Title: Advisory Committee on Reactor Safeguards  
610th Meeting

Date: Thursday, December 5, 2013

**Presentation to ACRS Full Committee  
U.S. EPR™  
Calvert Cliffs Nuclear Power Plant Unit 3  
FSAR Chapters 2.4, 2.5, 3, 9, 13 and 14  
December 5, 2013**

Figure 2.4-33— {Schematic Diagram Wave Runup on the UHS Makeup Water Intake Structure (MWIS)}

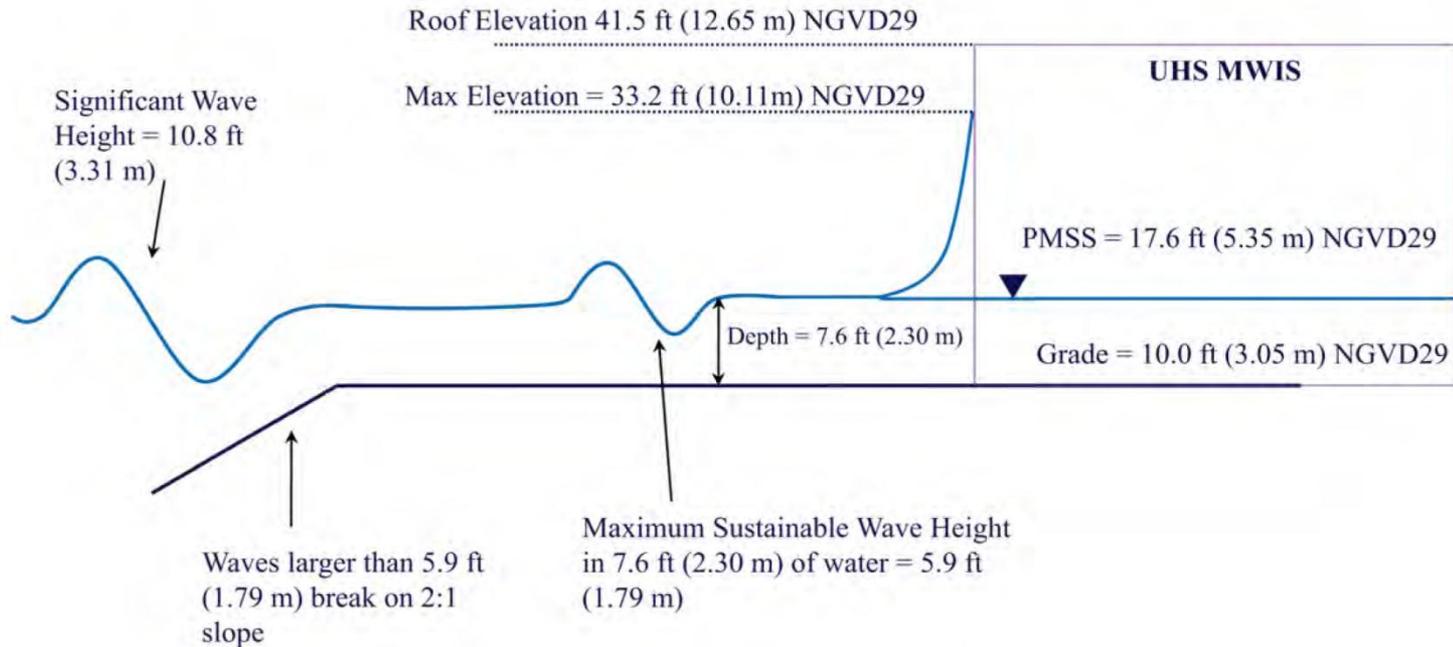
- The maximum wave runup on the intake structure was computed to be 15.6 ft. This runup, combined with the PMSS, will reach an elevation of 33.2 ft NGVD 29 as shown on Figure 2.4-33.
